Notice of Submission on Proposed Plan Change 60

This is a submission on proposed Plan Change 60.

Submission by David Jarman, 1720 Hoskyns Road, Kirwee

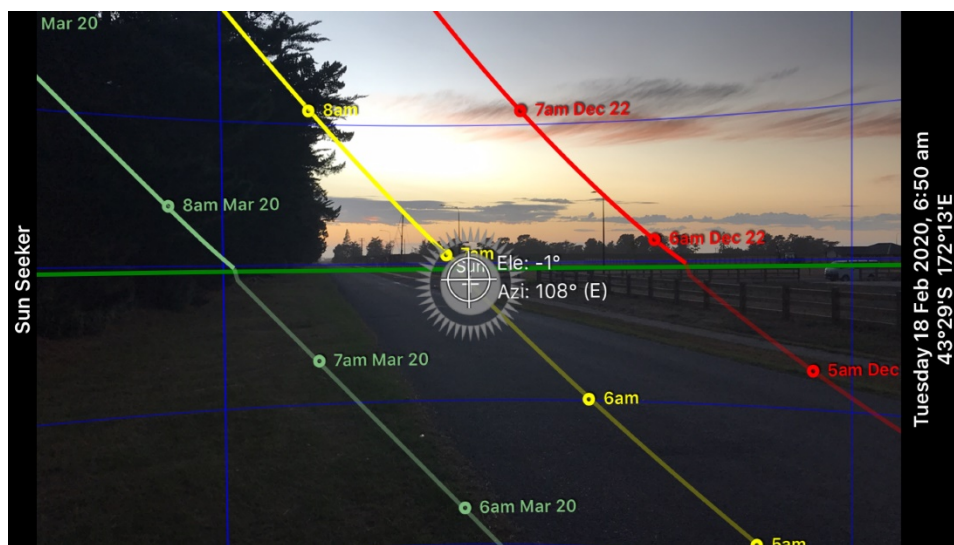
The below analysis, based on the information and assumptions shown in the Transportation Assessment, plus some further assumptions regarding the existing traffic on Hoskyns Rd shows the traffic that is expected to come specifically from the subdivision if PC60 is approved, and pass through the Suffolk Drive / Hoskyns Rd intersection.

The Transportation Assessment considers the impact of the additional traffic on Hoskyns Rd itself, as well as Courtenay Rd. However the issue that arises is not so much the additional traffic on Hoskyns Rd but the fact that there are expected to be 915 additional vehicle movements all passing through the Suffolk Drive / Hoskyns Road intersection each day.

Based on the Transportation consultant's report and some realistic assumptions applied above; at peak hour there is likely to be one vehicle passing through the Suffolk Drive / Hoskyns Road intersection every 24 seconds.

The imposition of such a high level of traffic on what is really a rural intersection could cause significant safety hazards. This has not been addressed in the Applicant's Transportation Assessment, in fact it has been glossed over.

The high level of traffic coming out of Suffolk Drive (135 during peak hour and 1190 during the day) compared to the low number travelling from the eastern end of Hoskyns Rd (est. 13 at peak hour and 75 during the day) could create a situation where Suffolk Dr users may tend to drive around the corner into Hoskyns Rd without stopping, paying little attention to the eastern side of Hoskyns Rd due to the unlikely event of a car coming towards them from the eastern end of Hoskyns Rd.

Recommendation:

The Council should not approve PC60 as the high volume of traffic generated by 118 additional sections would create a highly dangerous intersection at Suffolk Dr / Hoskyns Rd, especially with the sun angle in peak hour at certain times during the year.
